# **Alameda Creek Bridge Replacement Project**

ALAMEDA COUNTY, CALIFORNIA  
DISTRICT 4 – ALA – 84 (PM 13.0/13.6)  
EA 04-16030/EFIS 0400000429

## **Final Environmental Impact Report/ Environmental Assessment with Finding of No Significant Impact**

**August 2017**

Figure 54. Geotechnical Boring Plan

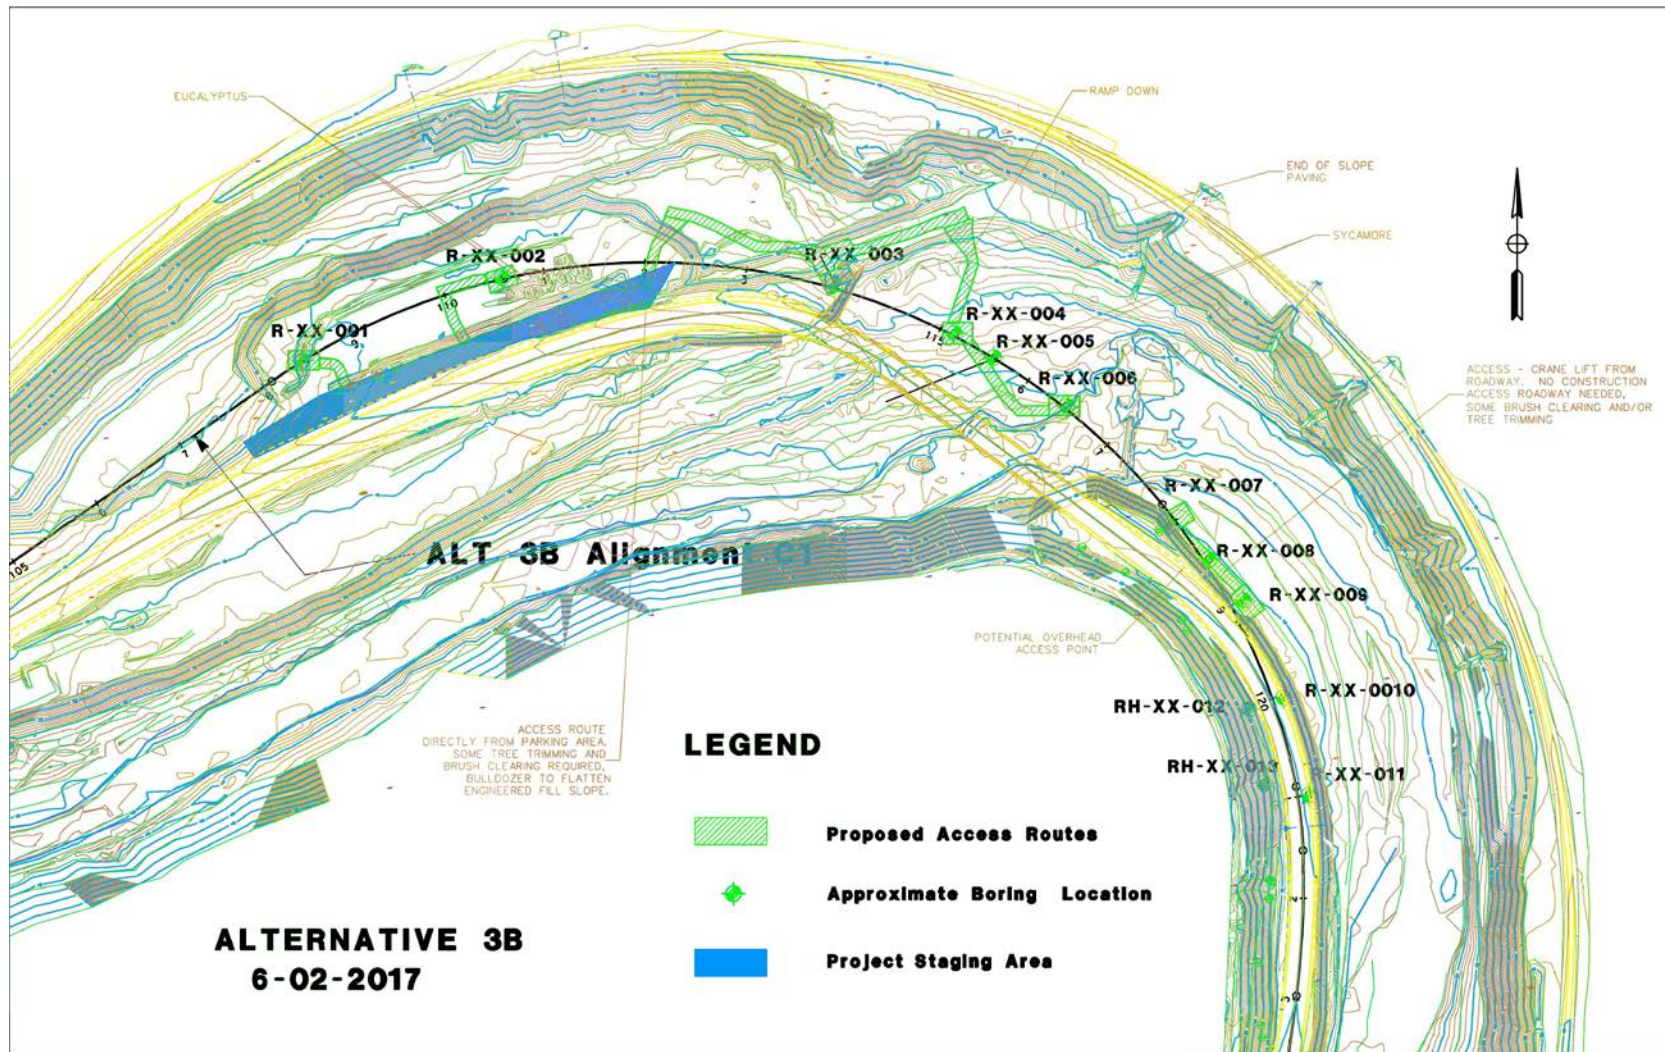
3 LJ-4.3	9	1.4.1 Common Features of all Build Alternatives - Geotechnical Investigations	"Caltrans plans to sample at approximately eleven locations within the project limits..."	N/A	Show the boring sample locations either in an existing figure or in a new figure.

The figure below identifies the locations of the borings and the proposed access road.
